City of Lewisville, TX
Planning and Zoning Commission
Agenda

SUBJECT: **Public Hearing: Consideration of an Amendment to Ordinance 0428-22-ZON, Known as the Castle Hills Planned Development, by Amending Section IV, Crown Centre Subdistrict, to Modify Concept Plan Requirements, List of Permitted Uses, Multi-Family Requirements, and Various Site Design and Development Standards. (Case No 25-12-5-PZ).**

RE: Crowne Centre - Planned Development Amendment Narrative

SUBJECT: **Public Hearing: Consideration of an Amendment to Ordinance 0428-22-ZON, Known as the Castle Hills Planned Development, by Amending Section IV, Crown Centre Subdistrict, to Modify the Concept Plan, Framework Plan, and Circulation Cross-Sections; on an Approximately 114.133-Acre Tract of Land out of the Samuel H. Hayden Survey, A-537, the J. E. McWhorter Survey, A-1690, and the B.B.B. And C.R.R. Co. Survey, A-180, Harrison Young Survey, A-1448, With Portions Legally Described as Crown Centre Tract A Phase 1 Addition, Block A, Lots 5x, 6, 7x, and 9; and Crown Centre Tract B Phase I Addition, Block A, Lot 2; Located on the Southwest Corner of State Highway 121 Business and State Highway 121 (Sam Rayburn Tollway) as R

Current Subarea 1 Concept Plan

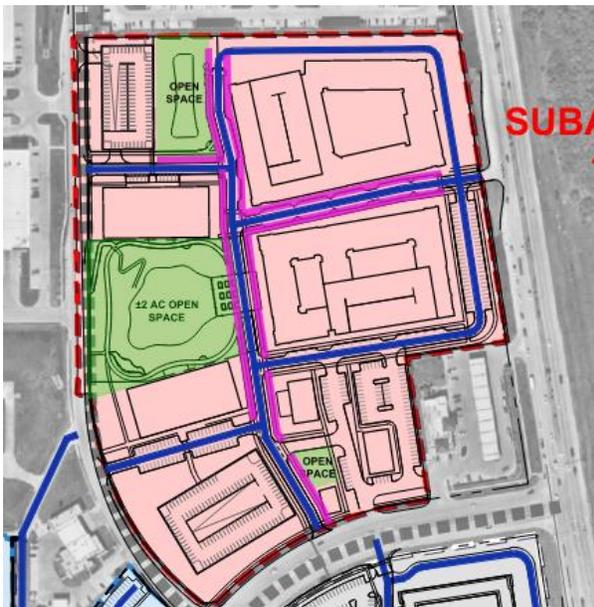
Subarea 1: Approximately half of this subarea, located adjacent to SH 121 Business to the north, Midway Road to the south and FM 544 to the east, is already built to the concept and framework plan’s specifications. Proposed changes to the southeastern properties show a surface parked retail area in lieu of a structure-parked development.

Current Subarea 2 Concept Plan

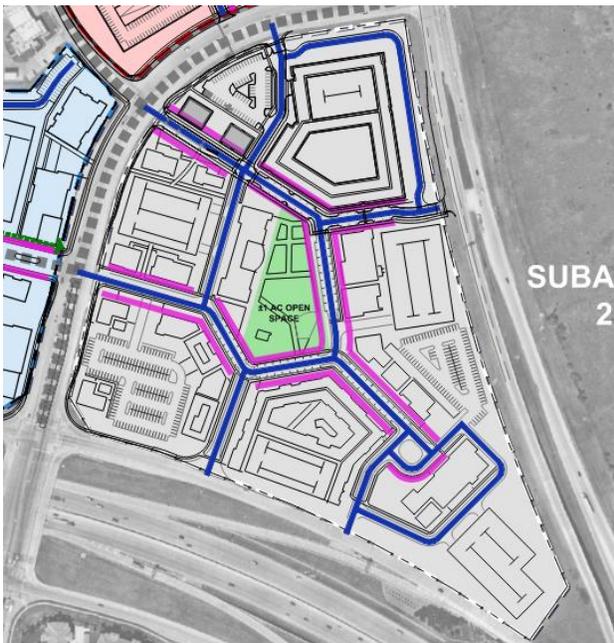
Subarea 2: This subarea, bounded by SH 121 Business, SH 121 and FM 544, is modified to allow for a large retail use such as a grocery store where smaller retail sites and office uses were once situated.

Proposed Subarea 3 Concept Plan

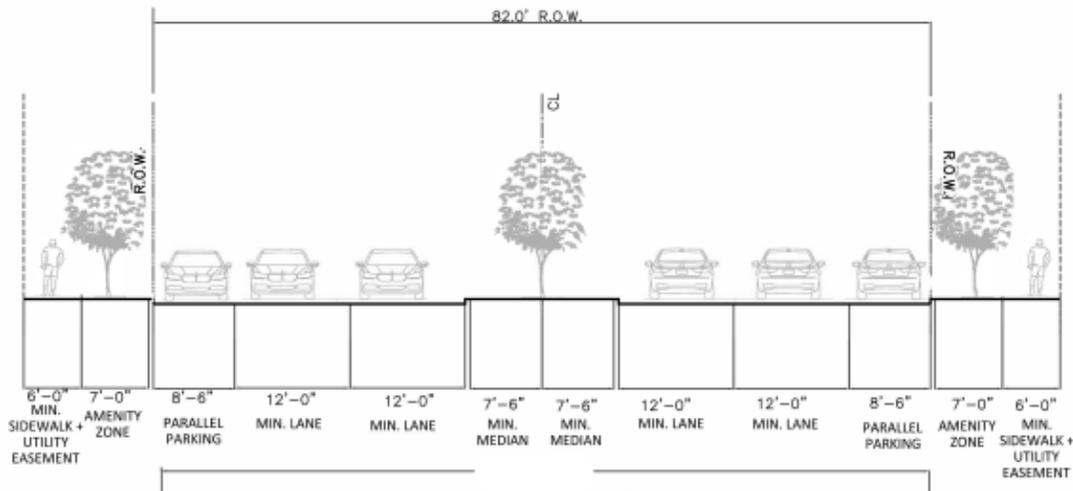
Subarea 3: This subarea is bounded by the SH 121 service road on the east and FM 544 on the north. The northern portion of this subarea south of FM 544 remains largely unchanged except for the addition of a retail/restaurant cluster on the north side of the large central open space and west of the central spine road. The area south of the large central open space has changed significantly with the addition of multi-family and commercial buildings on each side of the central spine road and retail/restaurant buildings along the SH 121 frontage road. These changes are being made to activate the existing and proposed office buildings situated at the southern end of this subarea. The inspiration for this change is the portion of The Realm Subdistrict of the Castle Hills PD along SH 121 where the addition of multi-family and retail/restaurant uses activated activity in the adjacent 9-story office building. The proposed framework plan shows areas where critical pedestrian connectivity is required to these new sites.
